June 9, 2023

City of Aurora
Planning and Development Services Dept
15151 E. Alameda Parkway, Suite 2300
Aurora, CO 80012

**RE: Antelope Creek (Kings Point North) 2nd Submission Review Response to Comments
CN#: 2022-6050-00; 2022-3081-00**

ANTELOPE CREEK INFRASTRUCTURE SITE PLAN
 GRADING PLAN 2

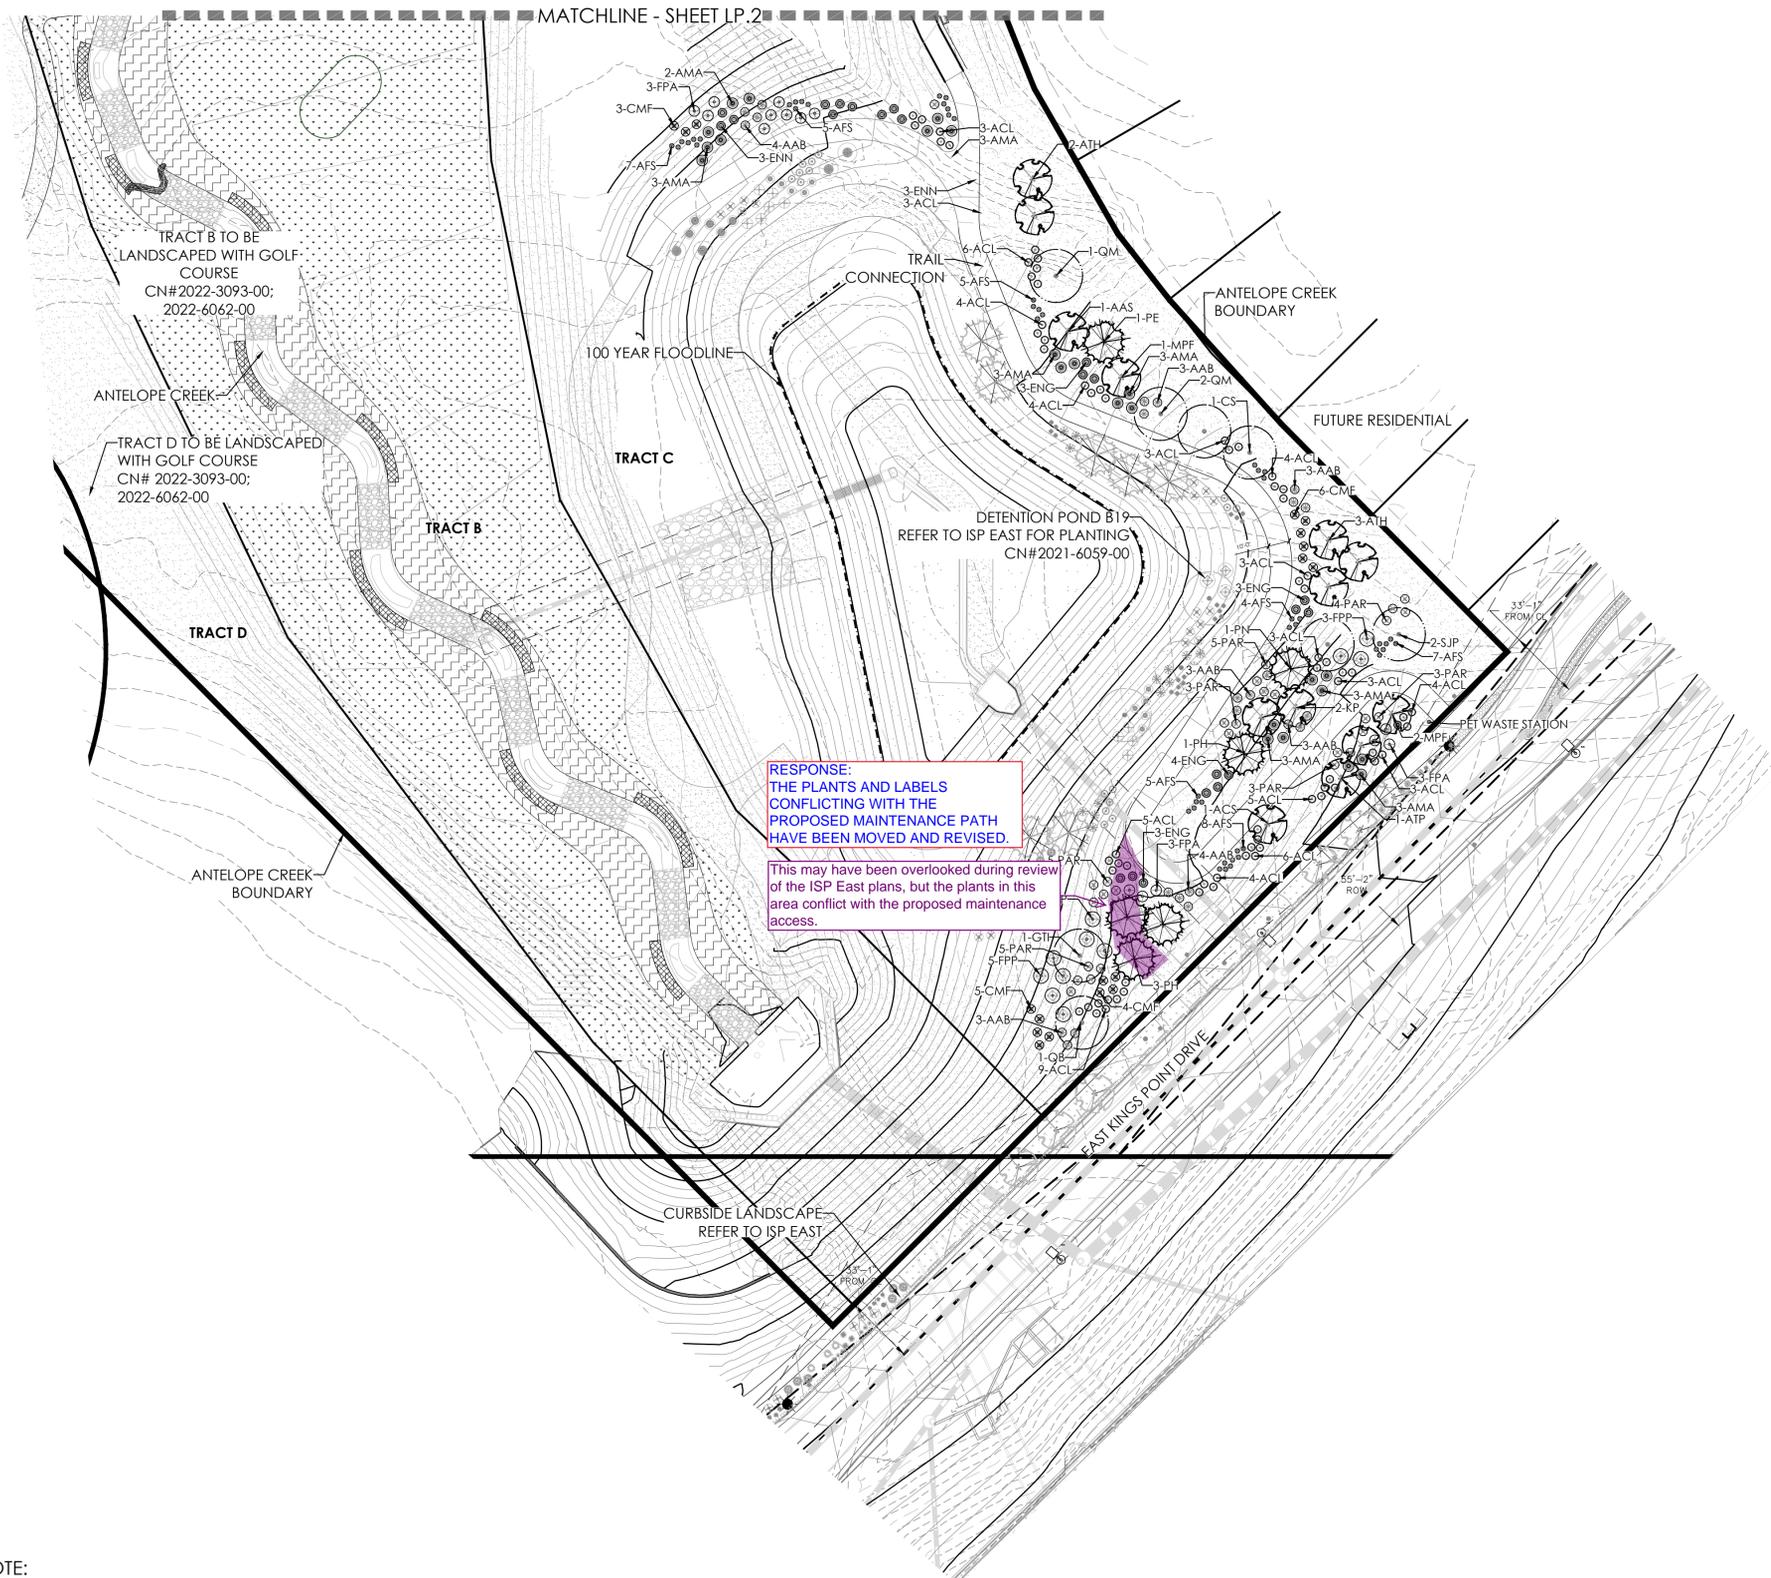
- b. Check this area. Max 3:1 slopes. Pedestrian railing is required for sidewalks adjacent to 3:1 slopes.
RESPONSE: Noted. Per discussions with Curt Bish and the City of Aurora, slopes adjacent to trails and pathways have been reduced to be less than 3:1 to eliminate the need for additional handrail.
- c. Pedestrian railing is required adjacent to 3:1 slopes per Section 4.02.6 of the Roadway Manual.

- i. A barrier, such as a pedestrian railing, should be placed at the outside edge of the 2' recovery zone where the adjacent slope is 33.33% or steeper with a 6' drop or greater. [2 comments]

A barrier, such as a pedestrian railing, should be placed at the outside edge of the 2' recovery zone where the adjacent slope is 33.33% or steeper with a 6' drop or greater.

RESPONSE: Noted. Per discussions with Curt Bish and the City of Aurora, slopes adjacent to trails and pathways have been reduced to be less than 3:1 to eliminate the need for additional handrail or rumble strips.

CORE RESPONSE: Slopes have been reduced to 30% to negate need for railing.

LP.3

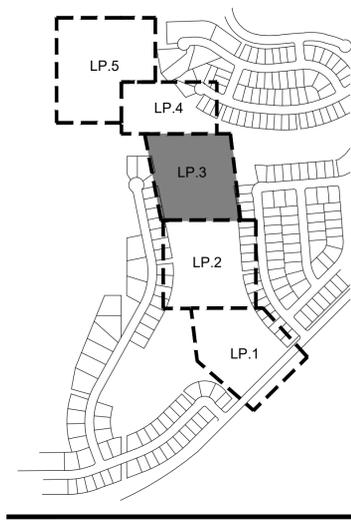
- j. This may have been overlooked during review of the ISP East plans, but the plants in this area conflict with the proposed maintenance access.

- k. Have these legends on each landscape plan sheet been updated? Is Winter King Hawthorn still being proposed, as it's no longer in the plant schedule on sheet LN.2.

Have these legends on each landscape plan
sheet been updated? Is Winter King
Hawthorn still being proposed, as it's no
longer in the plant schedule on sheet LN.2.

This may have been overlooked during review
of the ISP East plans, but the plants in this
area conflict with the proposed maintenance
access.

RESPONSE: The plants and labels conflicting with the proposed maintenance path have been moved and revised.

RESPONSE: Plant legends have been reviewed and updated per the plant schedule on LN.2.

RESPONSE:
PLANT LEGENDS HAVE BEEN REVIEWED
AND UPDATED PER THE PLAN SCHEDULE
ON LN.2.

RESPONSE:
THE PLANTS AND LABELS
CONFLICTING WITH THE
PROPOSED MAINTENANCE PATH
HAVE BEEN MOVED AND REVISED.

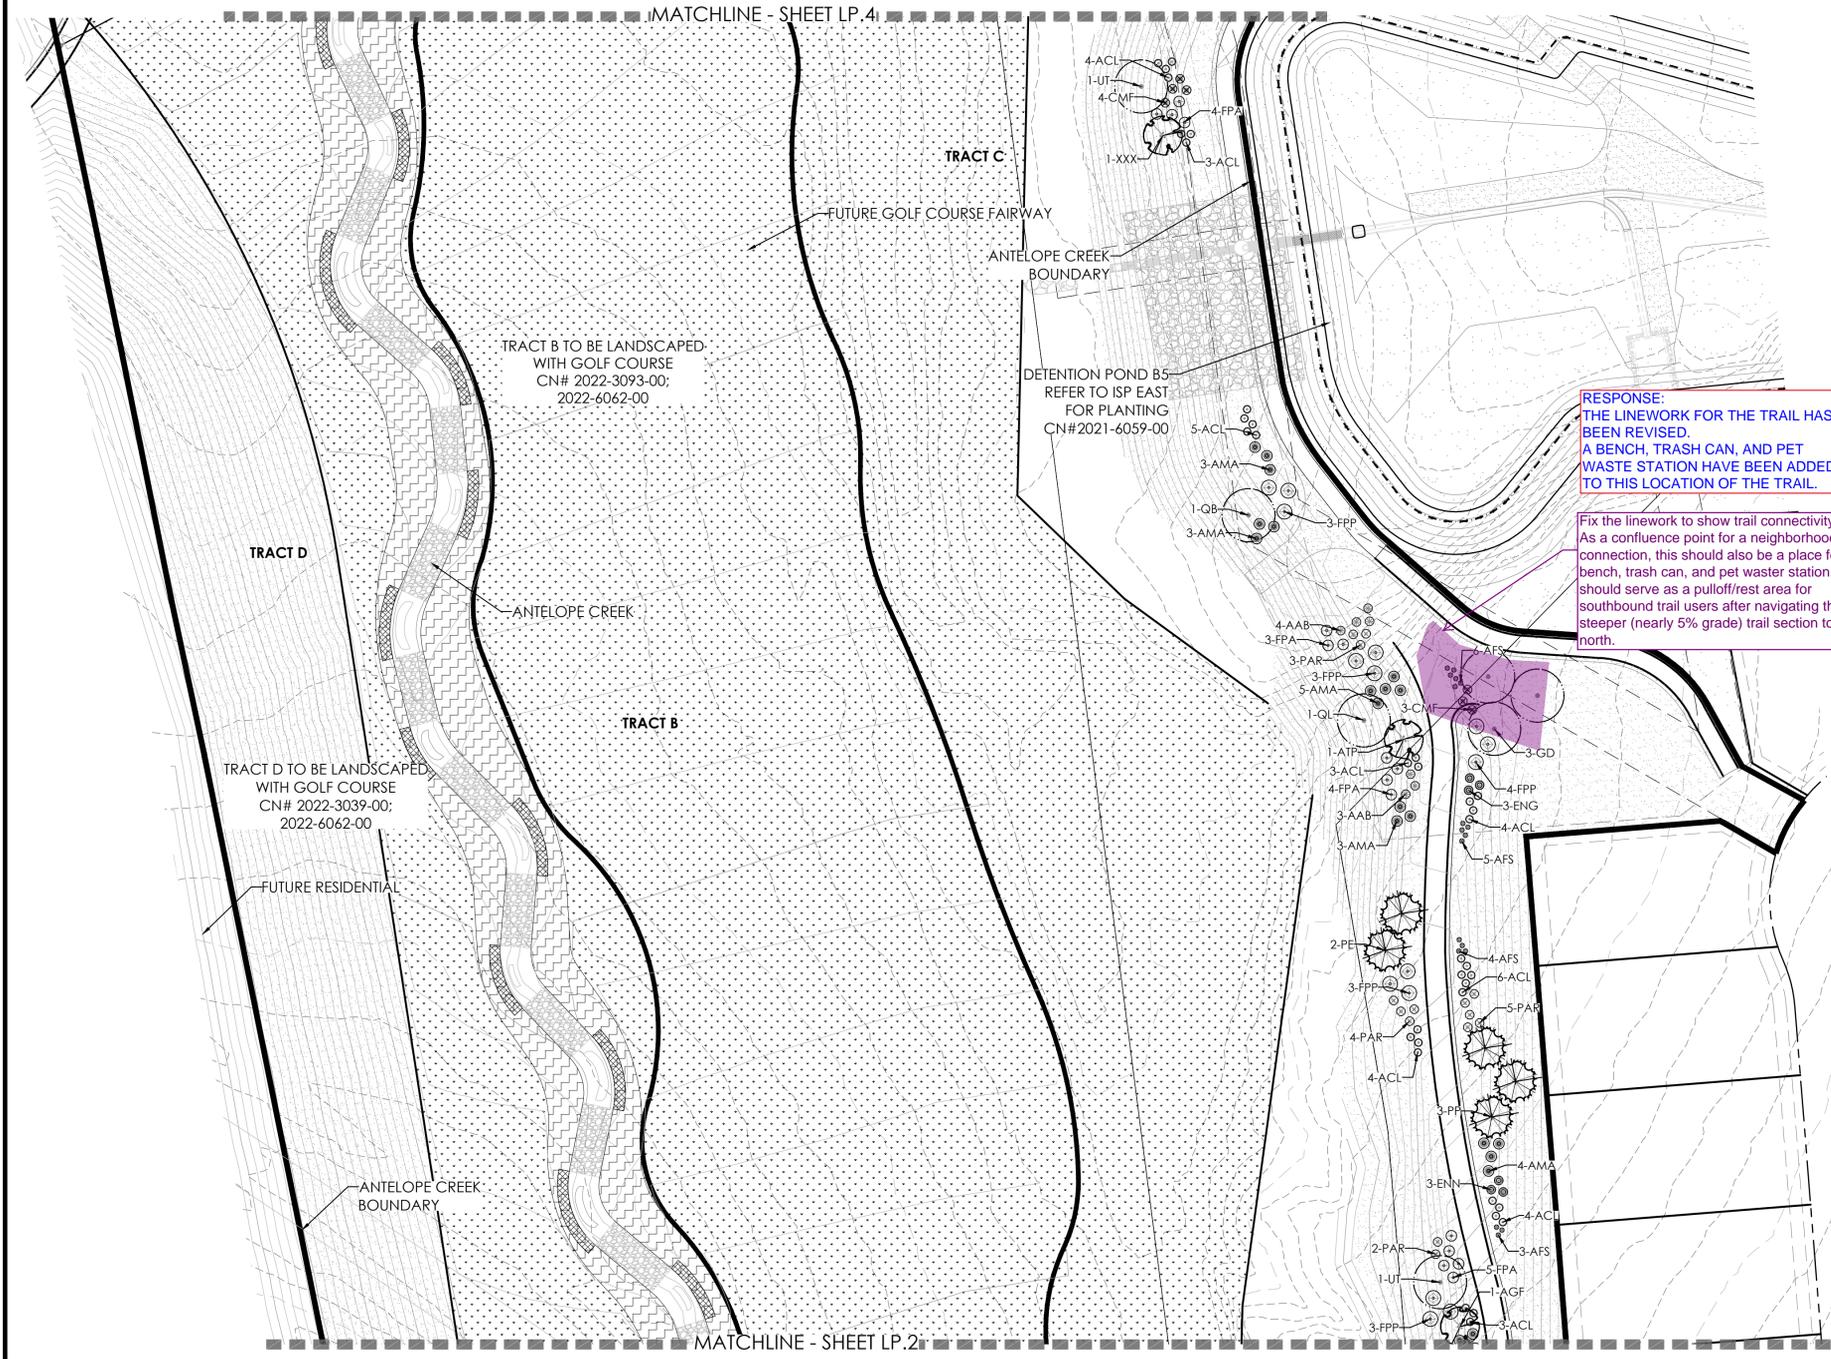
- l. Fix the linework to show trail connectivity. As a confluence point for a neighborhood connection, this should also be a place for a bench, trash can, and pet waster station. It should serve as a pull-off/rest area for southbound trail users after navigating the steeper (nearly 5% grade) trail section to the north.

Fix the line work to show trail connectivity. As a confluence point for a neighborhood connection, this should also be a place for a bench, trash can, and pet waster station. It should serve as a pulloff/rest area for southbound trail users after navigating the steeper (nearly 5% grade) trail section to the north.

RESPONSE: The linework for the trail has been revised.

RESPONSE:
THE LINEWORK FOR THE TRAIL HAS BEEN REVISED. A BENCH, TRASH CAN, AND PET WASTE STATION HAVE BEEN ADDED TO THIS LOCATION OF THE TRAIL.

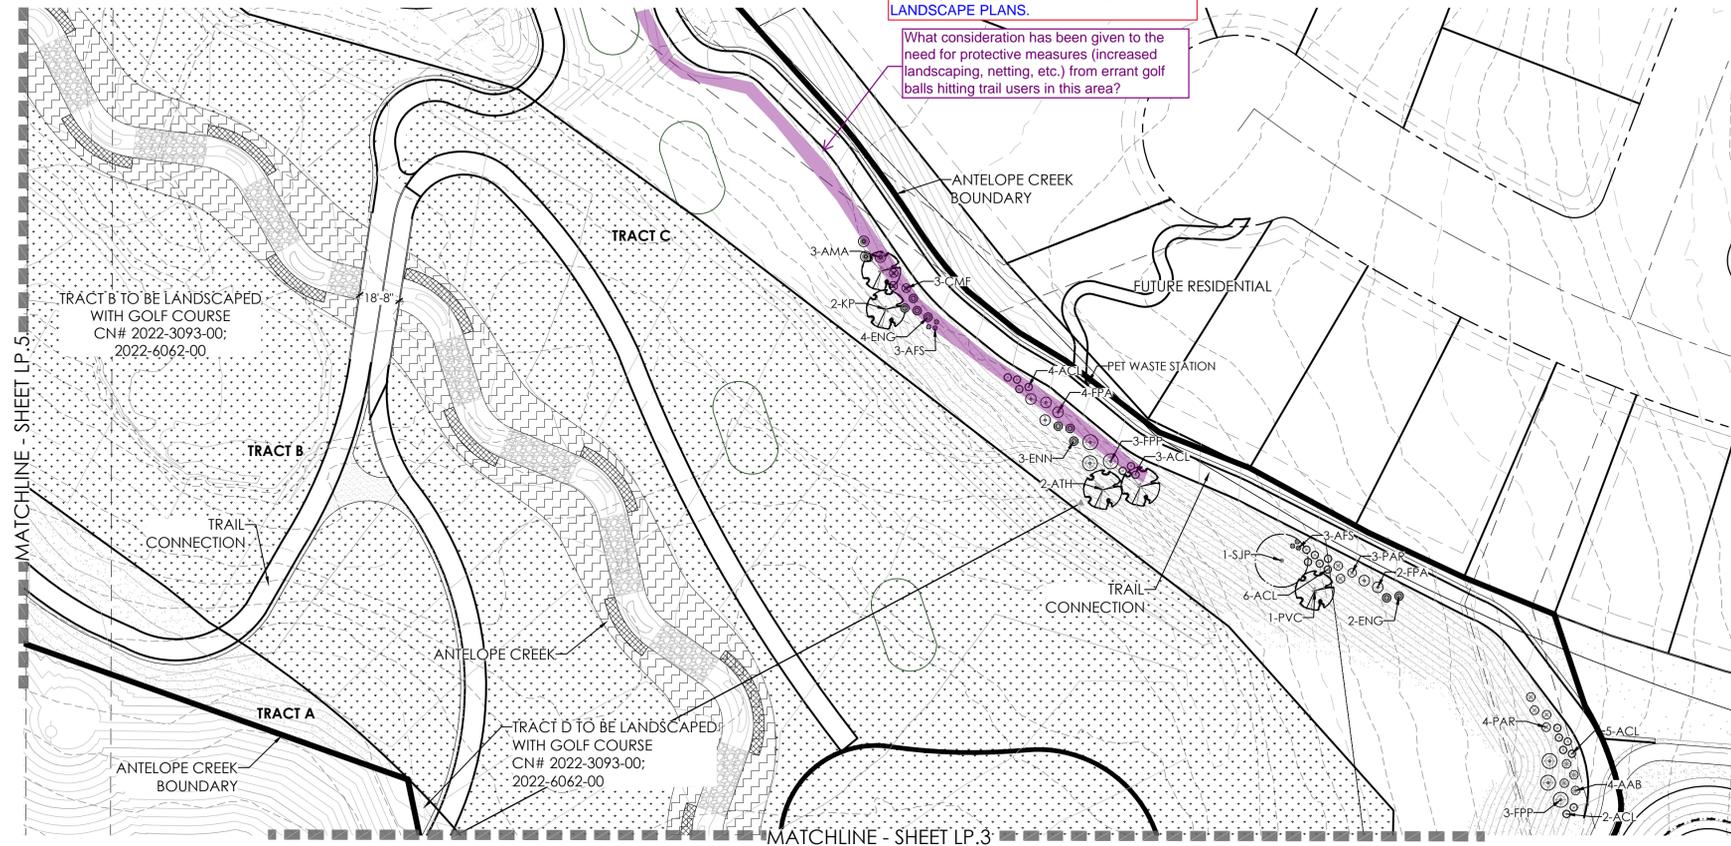
- m. What consideration has been given to the need for protective measures (increased landscaping, netting, etc.) from errant golf balls hitting trail users in this area?

What consideration has been given to the need for protective measures (increased landscaping, netting, etc.) from errant golf balls hitting trail users in this area?

RESPONSE: Based on previous discussion, consideration of protective measures have been decided. The trail has been redesigned and pulled away from the t-box.

Fencing along the trail has been added. Netting will not be utilized in this area.

Additional landscape will be added, please refer to the Golf Landscape Plans.

RESPONSE:
BASED ON PREVIOUS DISCUSSION, CONSIDERATION OF PROTECTIVE MEASURES HAVE BEEN DECIDED. THE TRAIL HAS BEEN REDESIGNED AND PULLED AWAY FROM THE T-BOX. FENCING ALONG THE TRAIL HAS BEEN ADDED. NETTING WILL NOT BE UTILIZED IN THIS AREA. ADDITIONAL LANDSCAPE WILL BE ADDED, PLEASE REFER TO GOLF LANDSCAPE PLANS.

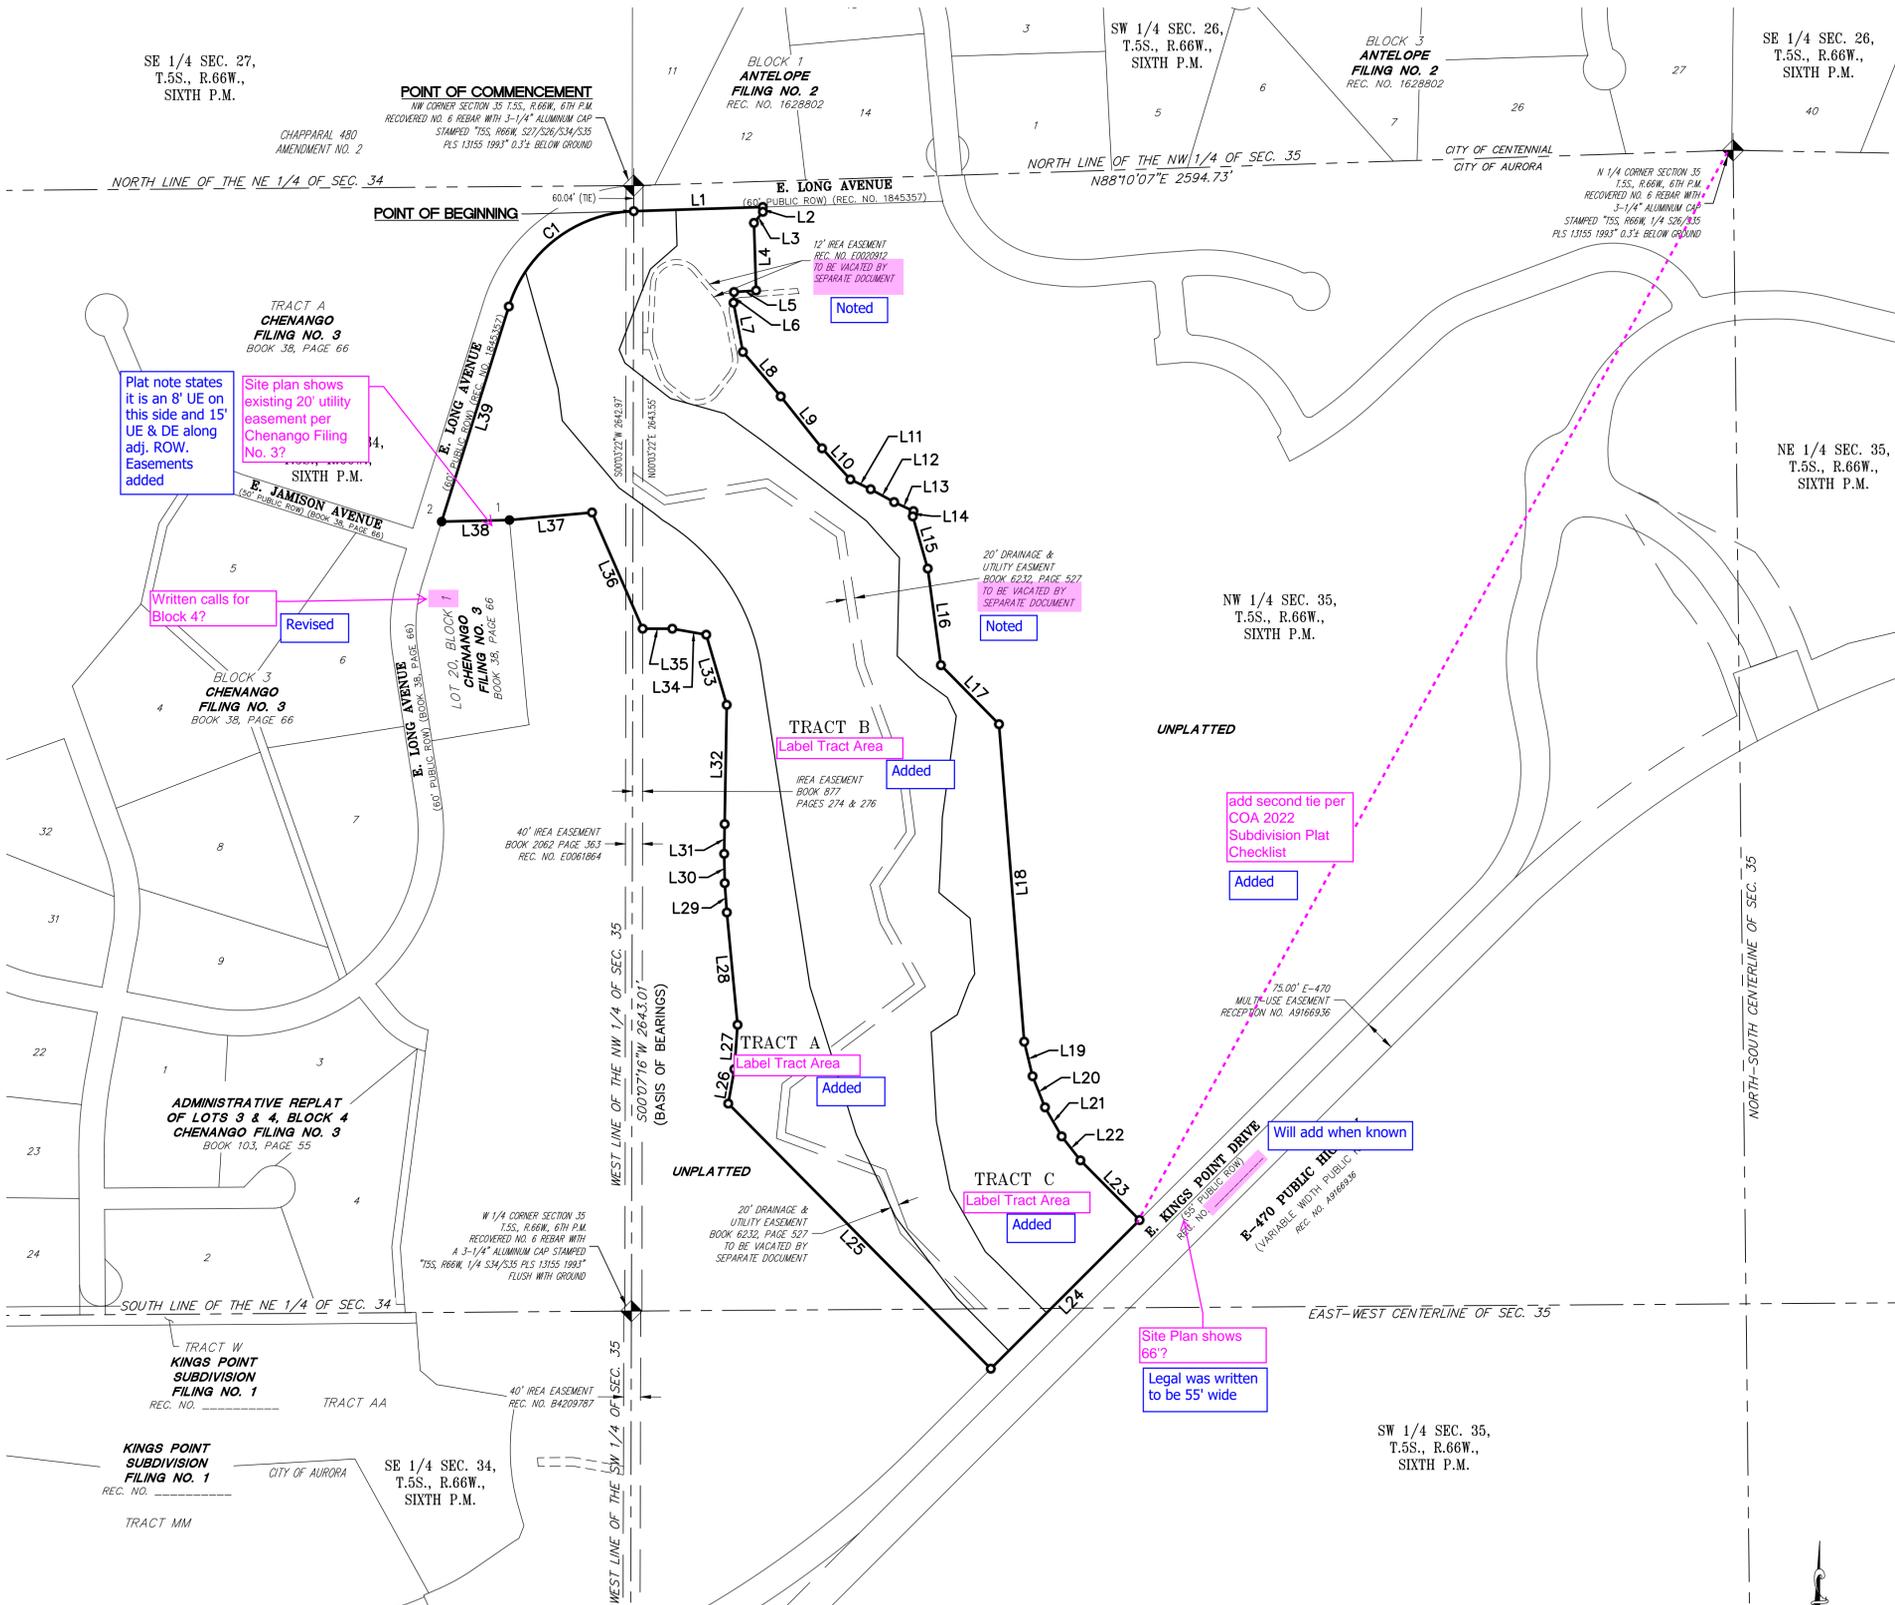
- n. Arapahoe County now requires this to be 3" x 7" rectangle.
RESPONSE: Revised
- o. Graphics shows Block 1?
RESPONSE: Graphic revised to Block 4
- p. Title work is now required to be dated within 30 days of plat acceptance date.

Graphics shows Block 1?

Graphics revised
